PSL - PMC

35.5 MHz Frequency Reference

Engineering Change Order History		
ECO number	Date	Originator
1		
2		
3		
4		
5

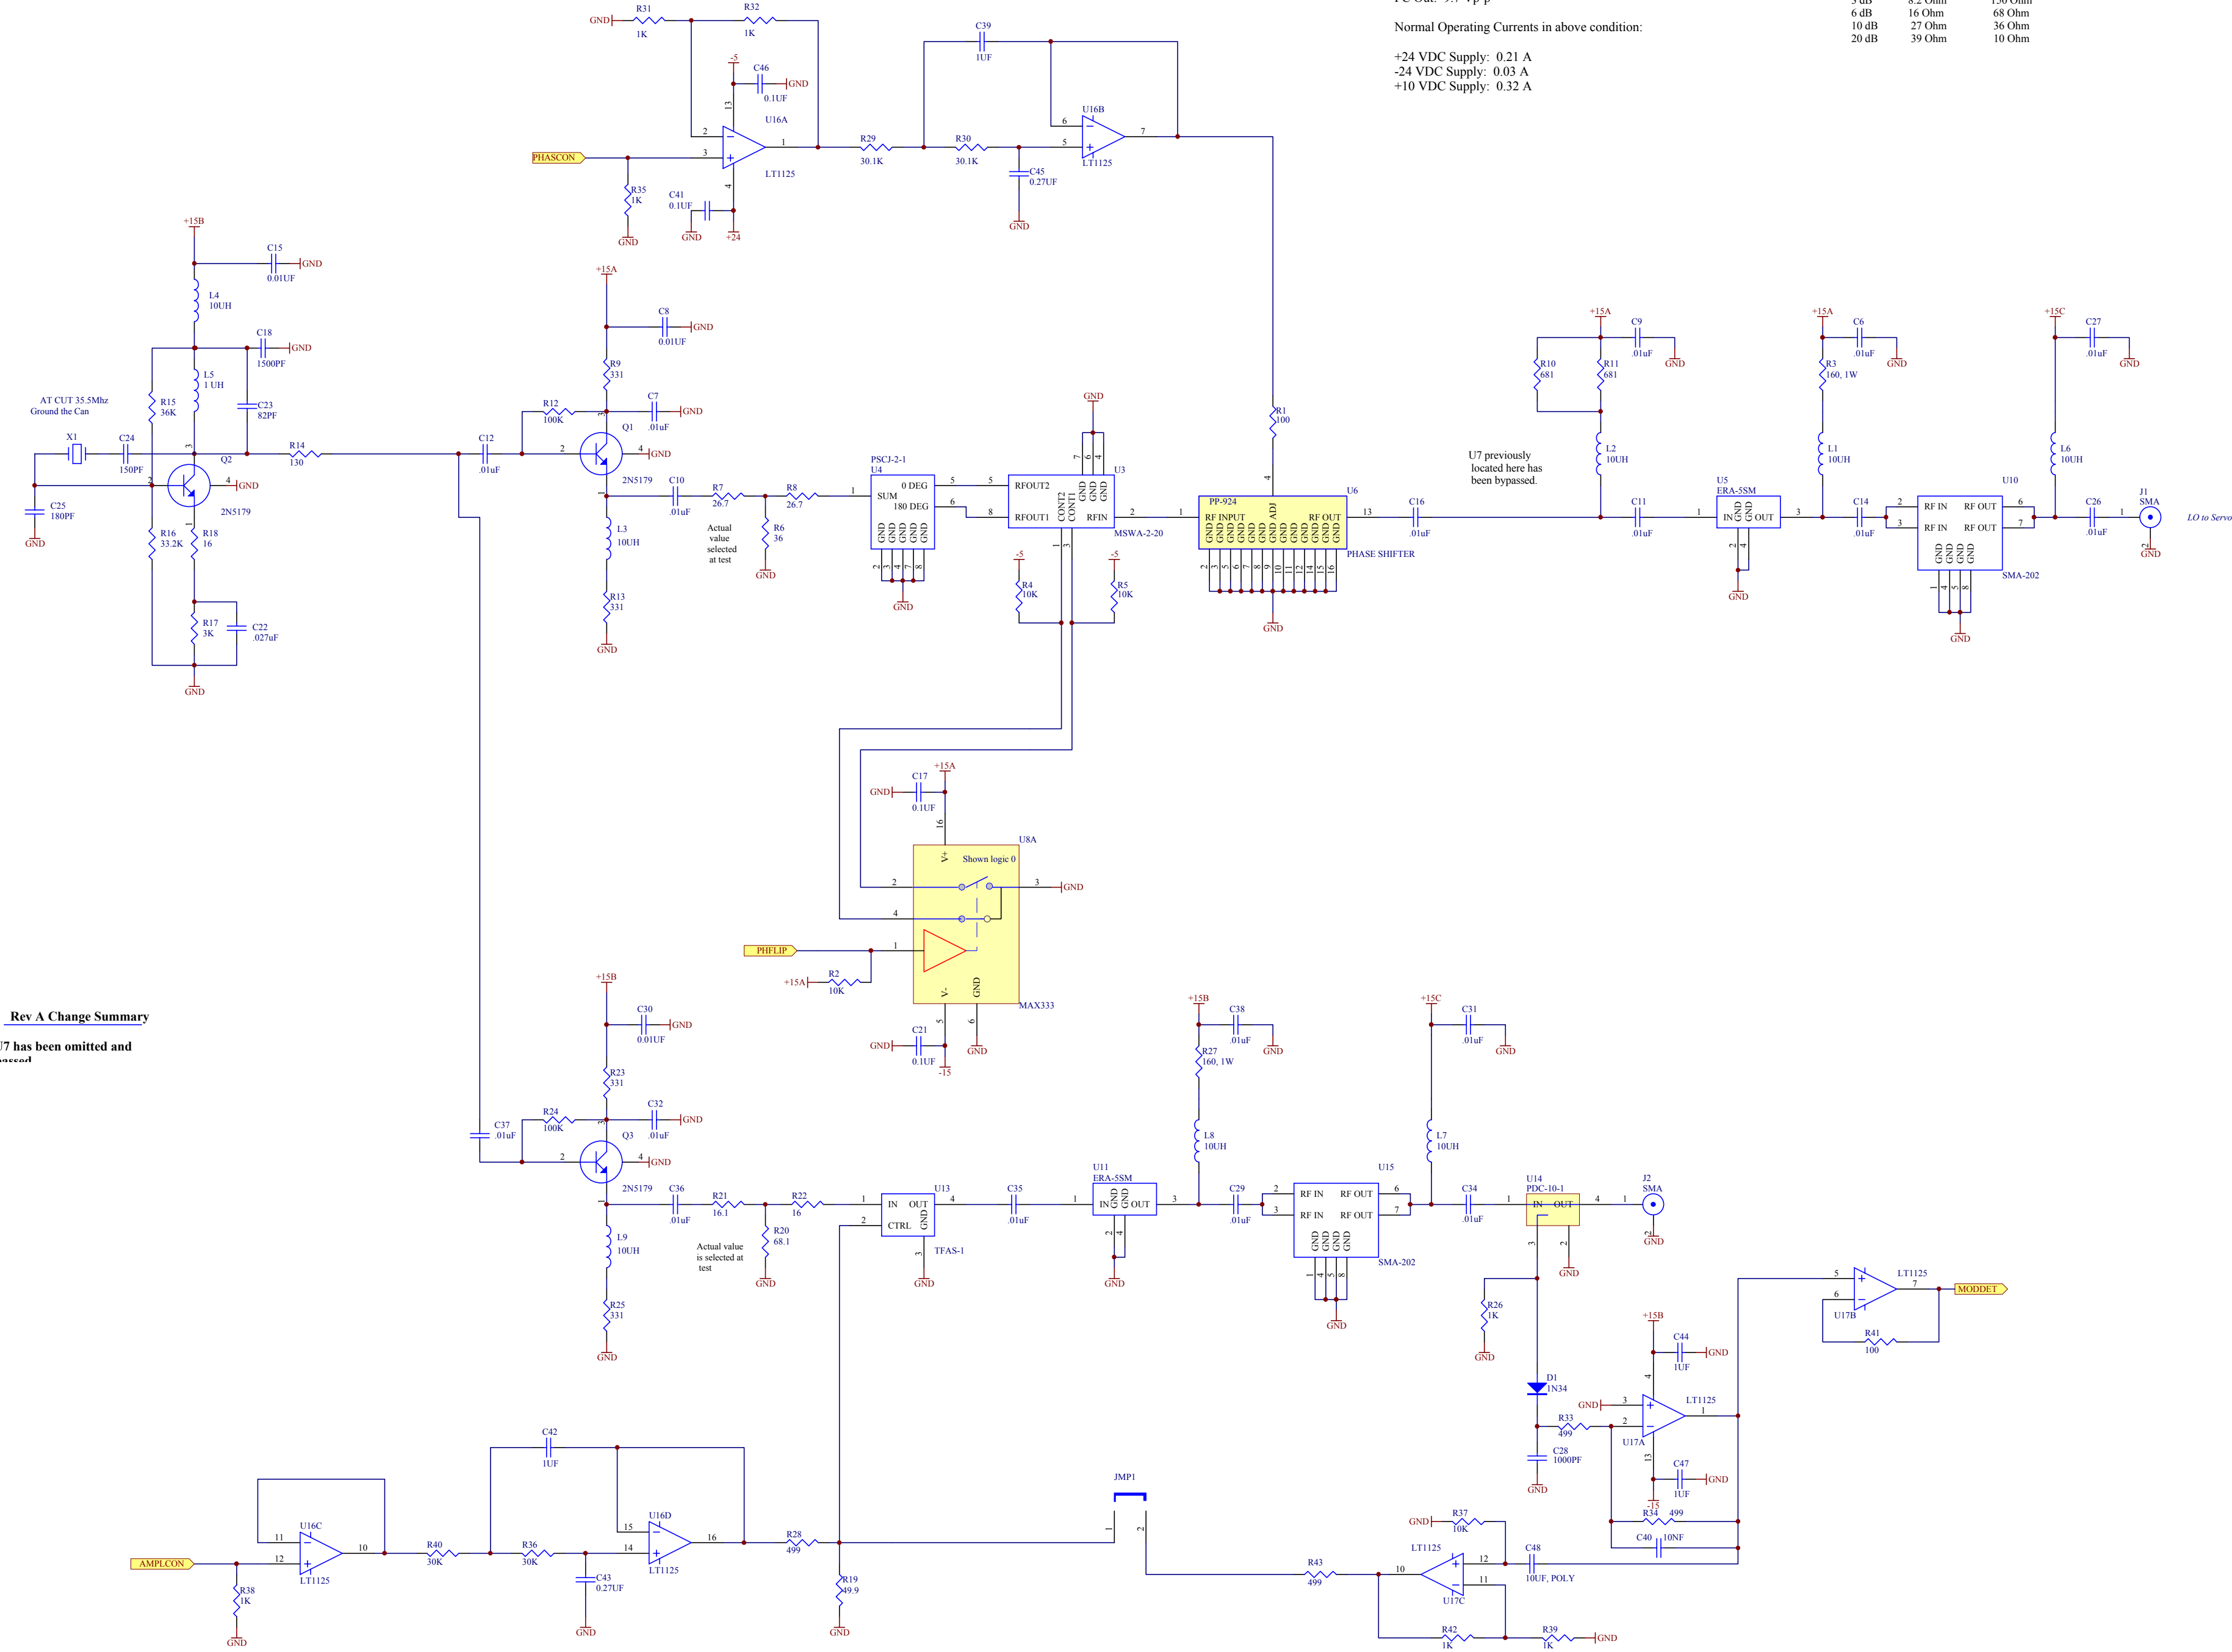
Rev A Change Summary
U7 has been omitted and bypassed
